REGIONAL REVIEW NOTIFICATION

ARC REVIEW CODE: R608241

Name of Proposal: Riverstone

Preliminary Report:	August 24, 2006	DEVELOPMENT OF REGIONAL IMPACT REVIEW REPORT	Project:	Riverstone #1113
Final Report Due:	September 7, 2006		Comments Due By:	September 23, 2006

D.R.I. MASTER PLAN RIVERSTONE LOCATED IN THE CITY OF CANTON BRIGHT - SASSER CANTON, L.L.C.

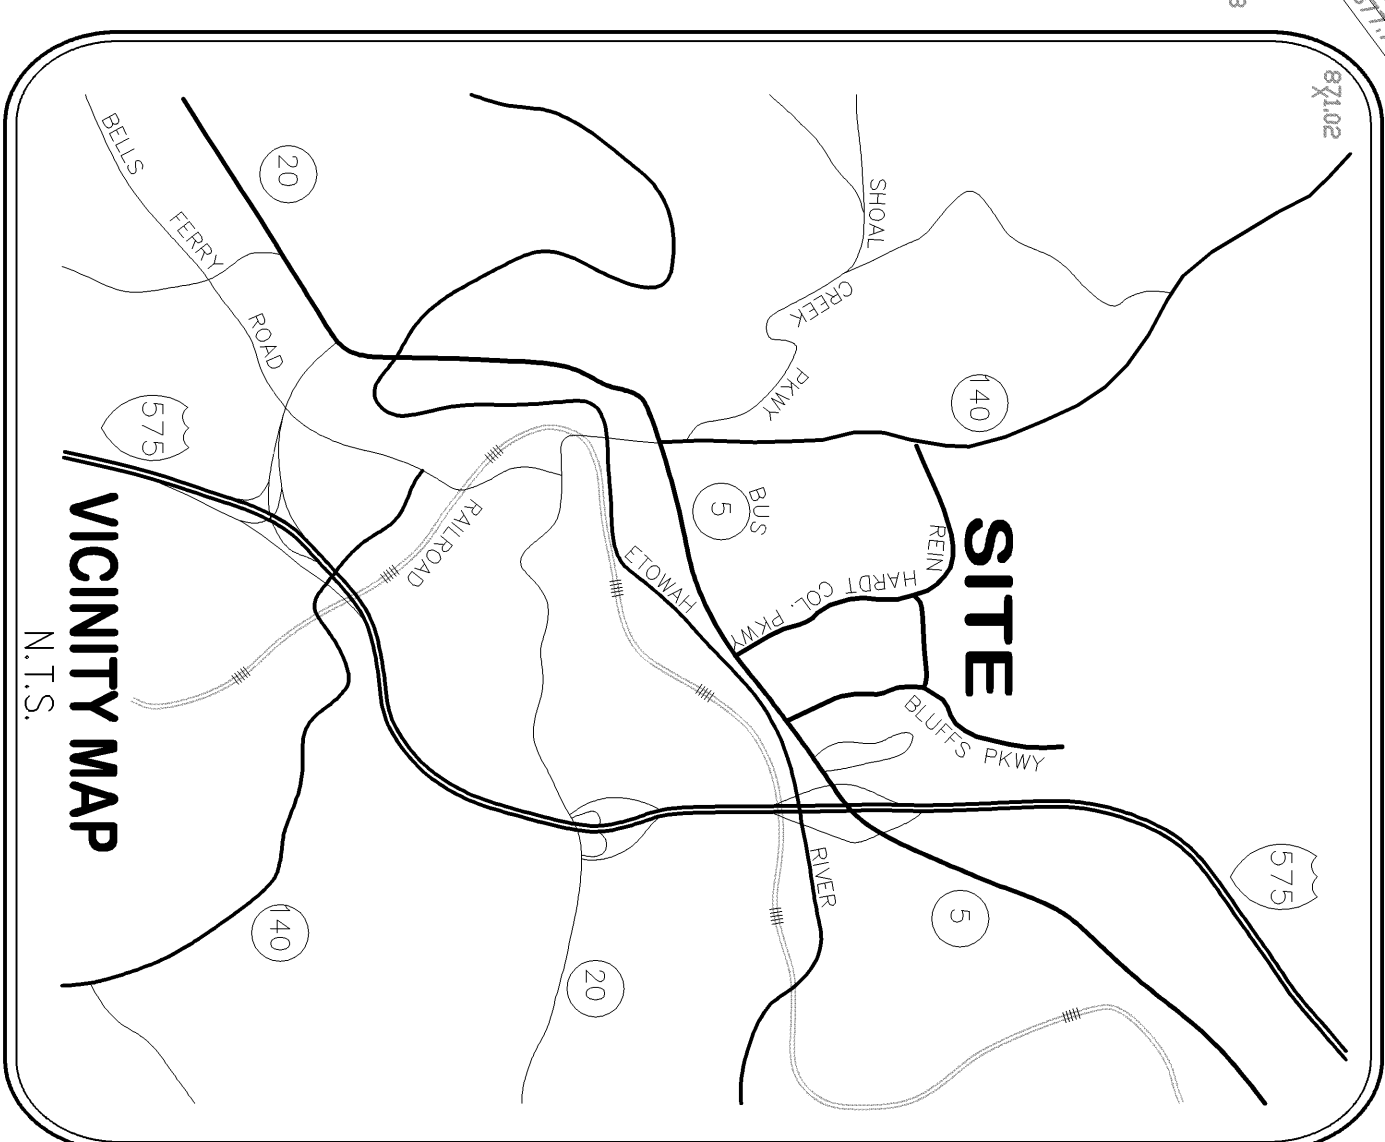
The proposed development provides multiple uses within the same site, yet fails to truly integrate those uses in a compact, vertical mix that encourages pedestrian movement and less dependence on the automobile. The commercial areas are dominated by parking lots and fail to give the community a sense of place. Less than 25 acres on the site plan is identified for open space. Amenity centers and clubhouses are proposed for the individuals residential pods.

Staff recommendations include refining the site plan to better integrate the proposed land uses where capable. Site plan recommendations include additional inclusion of passive and active park space. A centralized amenity center should be added to the overall development to provide a place for residents of the development to gather. Consideration of a greenway throughout the development to connect the various land uses and provide safe, convenient access to the various land uses within the development is strongly recommended. Outparcels located throughout the commercial pods should not have direct access onto roads, including Riverstone Boulevard, Bluffs Parkway, Riverstone Connector Road, and Reinhardt College Parkway. Future access points along Riverstone Blvd, Bluffs Parkway, and Reinhardt College Parkway should be minimized. Shared access points and internal connectivity within the individual pods should be implemented. Reduced parking spaces should be allowed to encourage alternative modes of travel throughout the entire development. The current free shuttle provided should be expanded to include stops throughout the residential areas, as well as the office and commercial areas.
